**IN THE DRAWINGS:**

## **REMARKS**

ANNOTATED SHEET

FIG. 2A

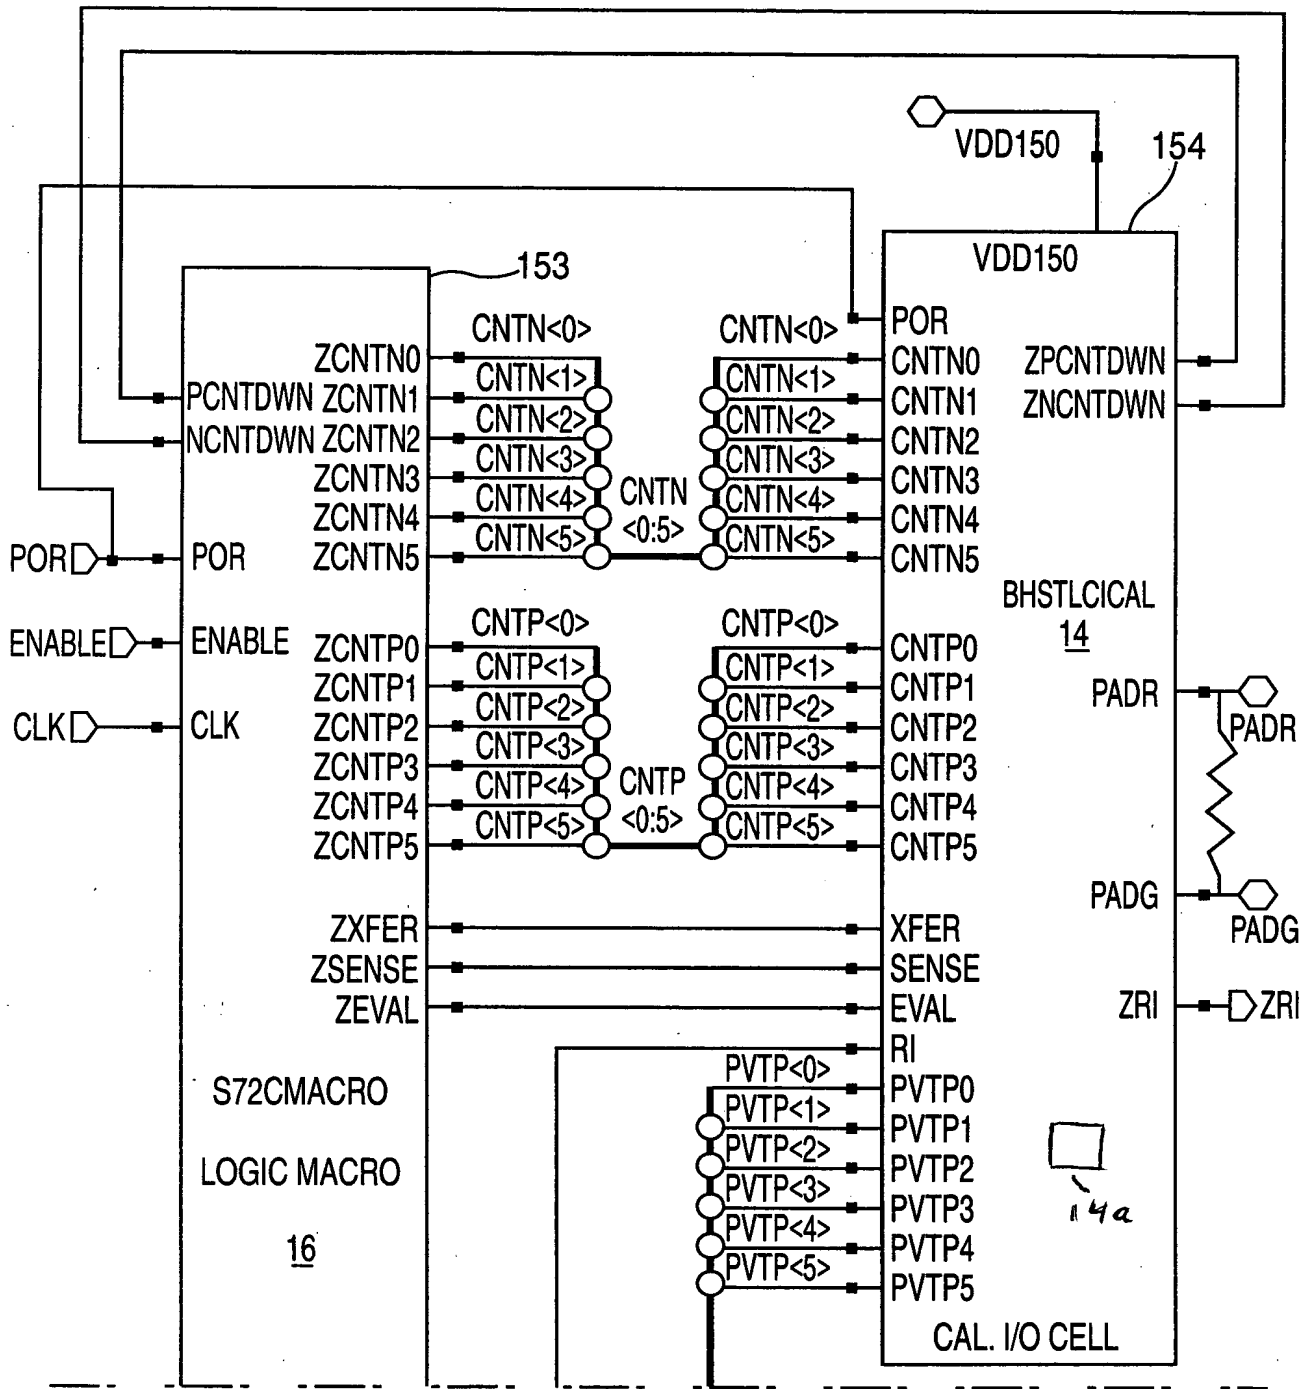
With respect to the drawings, the Examiner, in the Office Action, objected to Applicants' earlier corrections to Figure 2 on the grounds that the changes did not satisfy the requirements for formal drawings. The Examiner suggested making these changes to the formal drawings filed on February 7, 2002. The Examiner also noted that in Figure 3, "16" should be "12" and that in Figure 2B, "PVDRIVE" should be "PNDRIVE".

Replacement sheets showing these corrections to Figures 2A, 2B and 3 are being submitted herewith. Accordingly, the Examiner is asked to reconsider and to withdraw the objections to the drawings.
